Soft Bars service program

ATV Four Play would like to offer all Soft Bar owners a winter or “off season” service program.

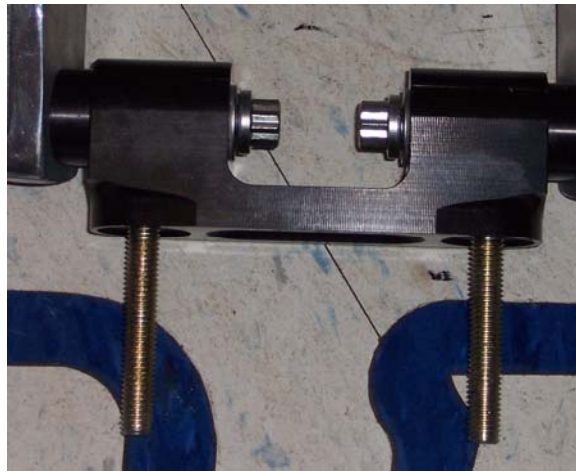
If you send in your Soft Bars, we will thoroughly inspect, clean and provide the 2010 stud updates. What does this mean? In our 2009 testing and R&D we have found that in a hard crash or if the bars are not completely tightened on to an aftermarket stem the 10mm studs can bend. So we have a new, stronger method of securing the Soft Bars to your aftermarket steering stem.

So, if your Soft Bars have 10mm studs that look like this:

OLD style

NEW Style

Send them back to us for the updates and we will inspect, clean and replace the dampening bushings, the O rings and grease the Soft bars for a low cost of \$25.00. This includes shipping back to you.
